Office Action Summary

This is an office action for serial number 09/822,154,
Suction Cup Holder.

3,181,702

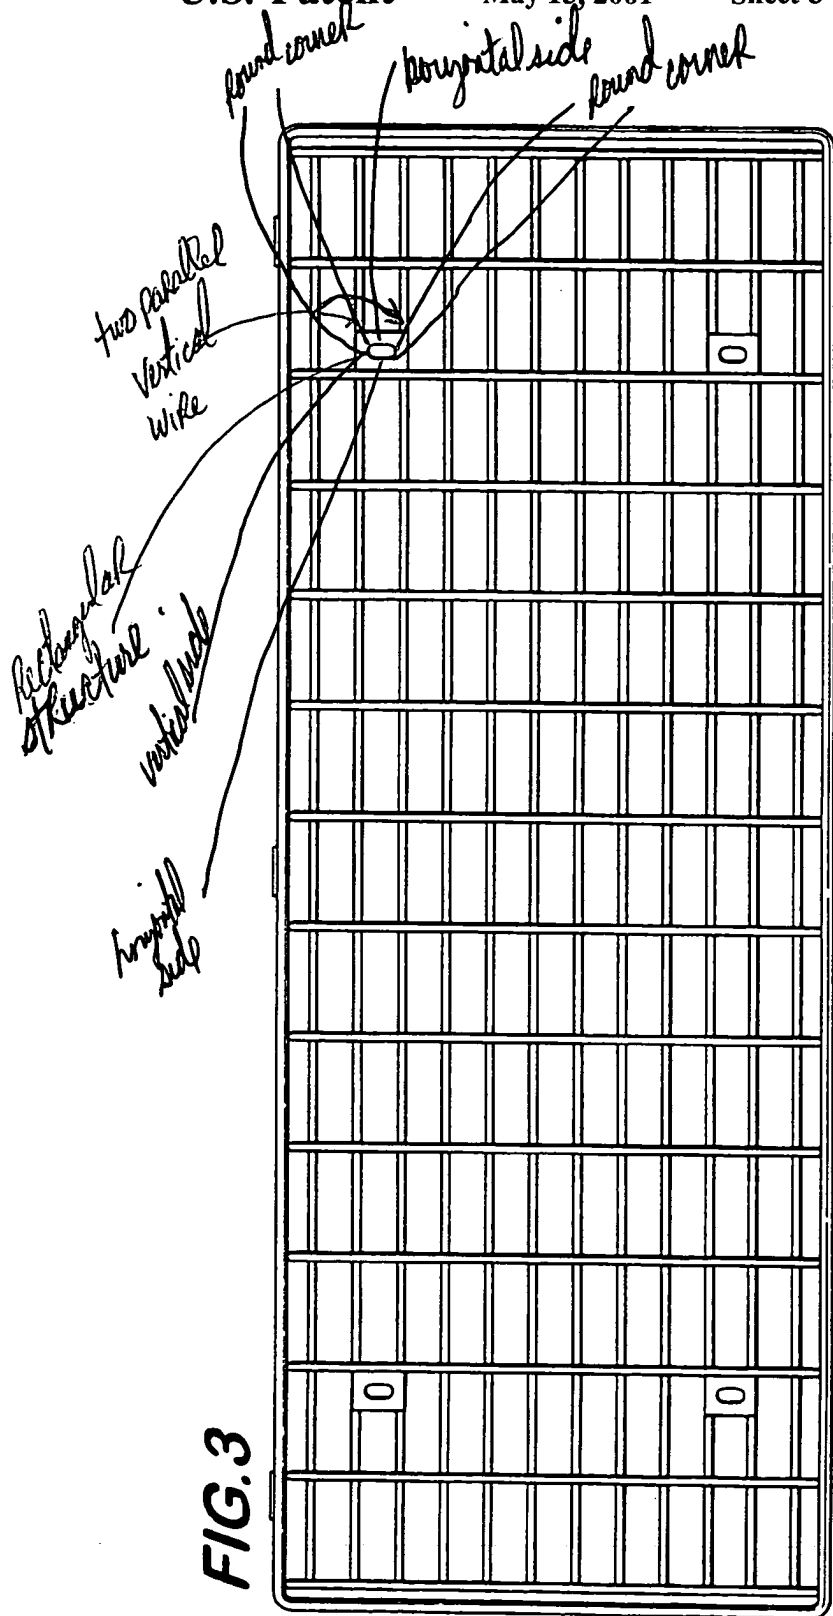
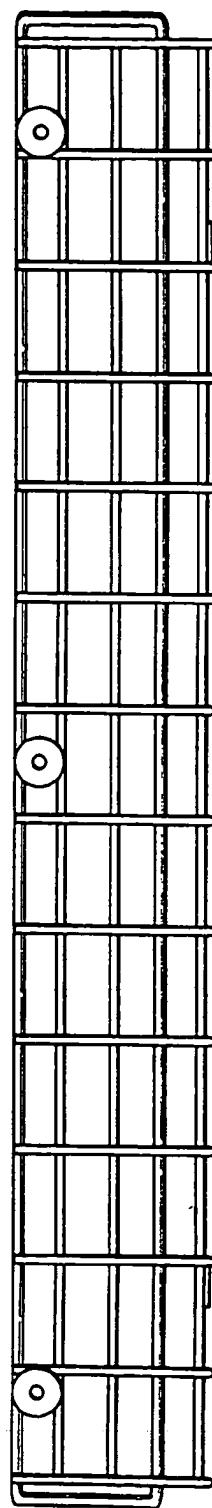
pair of horizontal wires (39 and 41), a second pair transverse wires (96), the wires defining a generally vertical rectangular opening (see attached figure), a suction cup with a head and a neck), two fastener arrangements (where the wires are attached to the fixture), and a fixture (50, 42, 43, 51, 52, 47, 48 and 53). The horizontal wire (41) retains the neck of the suction cup (66) within the opening. The wires are attached to the fixture by welds or at least one brazing (column 2, lines 56ff, where 52 and 53 are attached to 39 and where 47 and 48 are attached to 41). It would have been obvious to one having ordinary skill in the art to have modified Finger in view of Thalenfeld to have used the suction cup as taught by Raphael because these two suction cups are art-recognized equivalents at the time the invention was made, one of ordinary skill in the art would have found it obvious to substitute the suction cups.
